8494B-02

Modification Recommended Service Note

8494B – Manual Step Attenuator

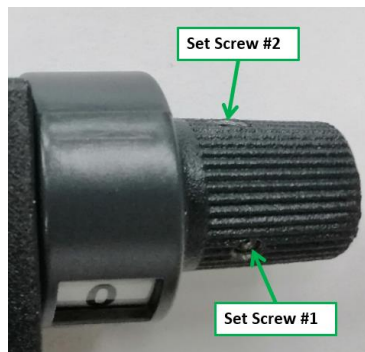
The attenuation knob was not securely tightened to the internal shaft, causing it to turn further. This is due to an insufficient torque that was applied to tighten the set screw during assembly at the factory.

This issue can be fixed by re-tightening the screws on the rotating knob.

- (1) Rotate the knob clockwise until it reaches the last attenuation step, which is at 0 dB.
- (2) Loosen the 2 set screws (0.05" Hex screw bit) on the knob slightly until the knob can freely move, and then align the knob so that the indicator label number "0" is located at center on dial cover window.

- (3) Tighten both set screws with a 0.05" Hex screw bit and 4.0in-lbs torque driver.

(4) After tightening both set screws, rotate knob counter-clockwise until it reaches the maximum attenuation (11/70/110dB). To ensure the attenuator functions properly, rotate the knob clockwise back to minimum attenuation (0dB), and repeat the movement for 10 cycles.
